# Detailed Site Plan DSP-20053-02
# Departure from Design Standards DPT-2025-0003
# West Hyattsville Phase 2 - ETOD

SUBJECT: Detailed Site Plan DSP-20053-02
Departure from Design Standards DPT-2025-0003
Type 2 Tree Conservation Plan TCP2-2025-0074
Alternative Compliance ACL-2025-0008
Expedited Transit-Oriented Development (ETOD) Project
West Hyattsville Phase 2

**1. Request**: The subject detailed site plan (DSP) is for approval of a residential building consisting of 342 multifamily dwelling units and an associated parking garage and plaza on proposed Parcel 2.

| SHEET 4 OF 4 | |

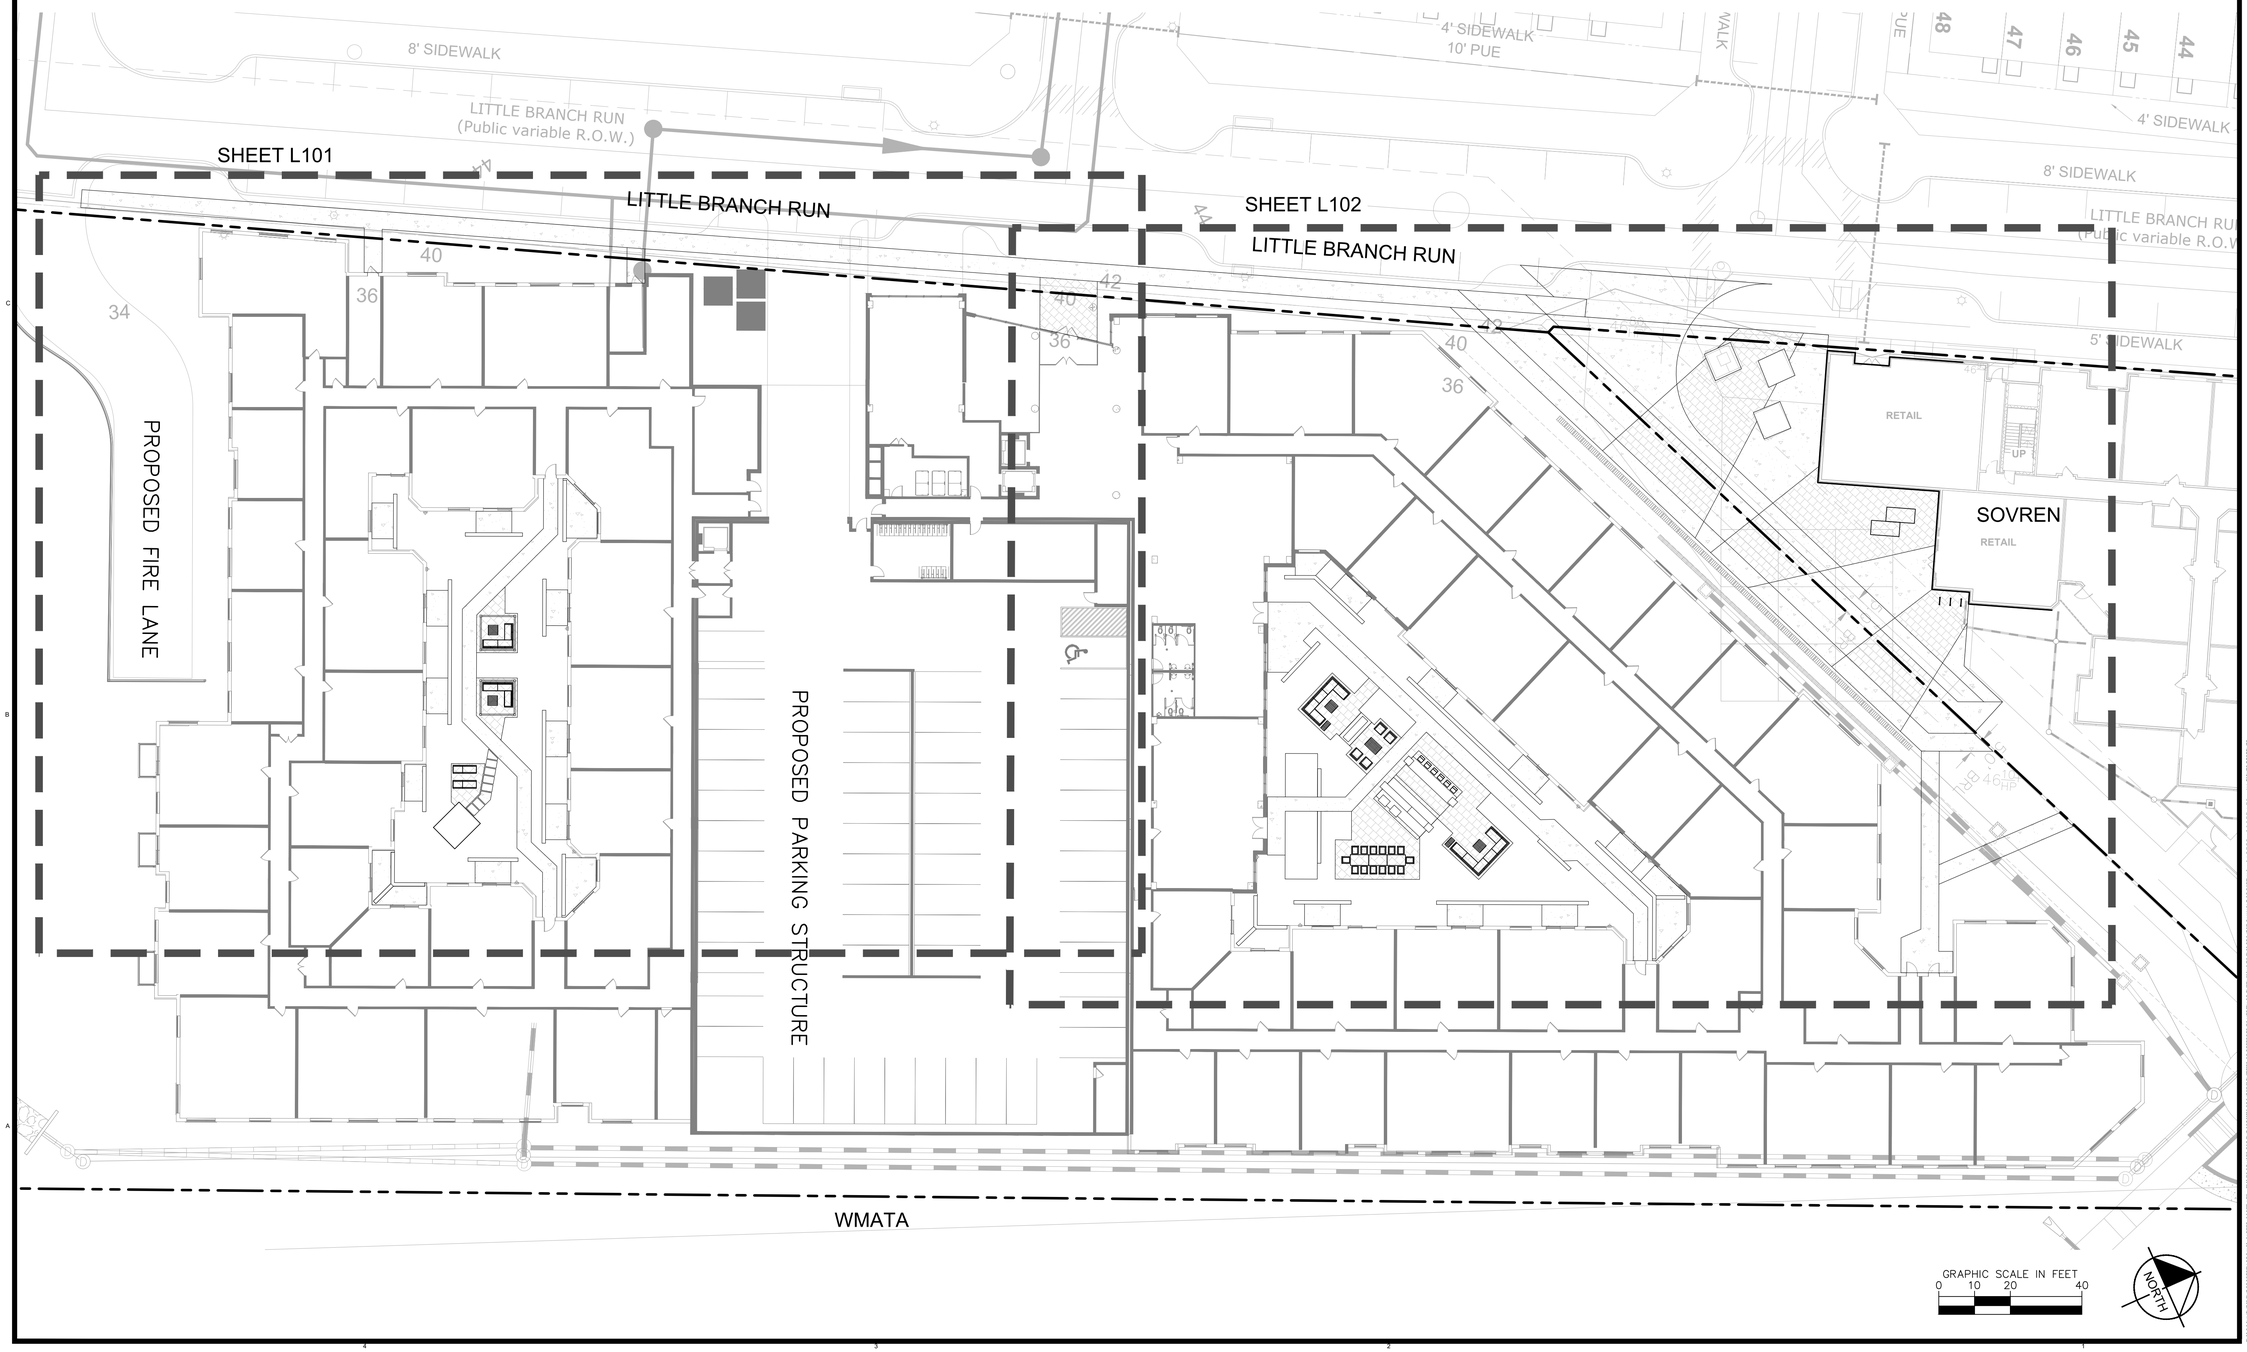
**Comment:** The extension of the 5-foot-wide sidewalks along the subject property's frontage of Little Branch Run until the point of vehicle entry for Parcel 2 and to the Northwest Branch Trail is identified on sheets 3 and 4. The bicycle parking in the parking garage for residential uses and on-site or in the right-of-way for nonresidential uses that is consistent with 2006 *Approved Transit District Development Plan and Transit District Overlay Zone* standards and bicycle fix-it station proposed within the garage is identified on sheet 4. Continental style crosswalks crossing the garage and loading zone access points are identified on sheet 4. The pedestrian and bicycle shared-use path through the property from the western side of the subject site near Emerald Branch Drive to the pedestrian tunnel to the West Hyattsville Metro Station is identified on sheets 3 and 4. This condition has been met.

**Comment**: While the Riverfront Connector is not a master planned facility, the site plan identifies this as a five-foot-wide sidewalk that connects with the Northwest Branch Trail along the southern portion of the subject property, shown on sheet 4.
